Technical Bulletin

72 14 01 November 17, 2014 2038960

Front Seat Creaking Noise

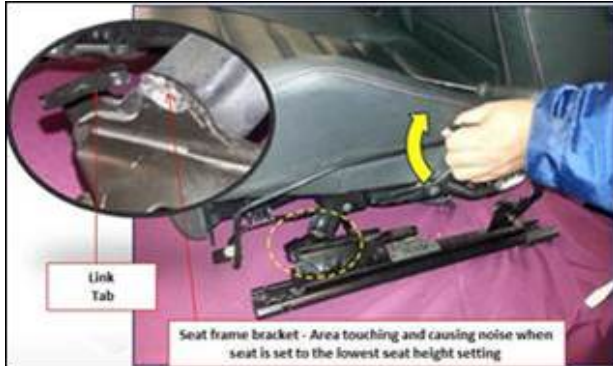
On the outboard side of the front seats there is a link tab that is contacting the seat frame. The gap between this tab and the seat frame should be a minimum of 1mm.

Supplier has corrected the production process to create the proper gap between the link tab and the seat frame.

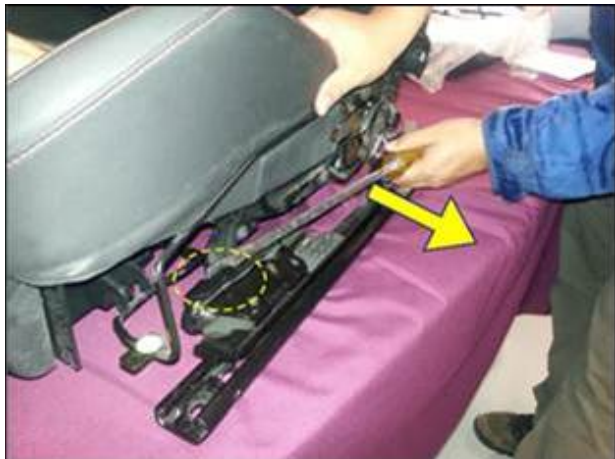
- 5. Check if the link tab is touching the seat frame track bracket.
 - a. If contact is found continue to step 6.
 - b. If contact is not found continue diagnosis. This bulletin does not apply.

- 6. Raise the seat back up. Using a large flat head screw driver, place the screw driver blade between the link tab and the track bracket.

- 7. Keep the screw driver positioned between the link tab and the track bracket and adjust the seat height to the lowest setting.
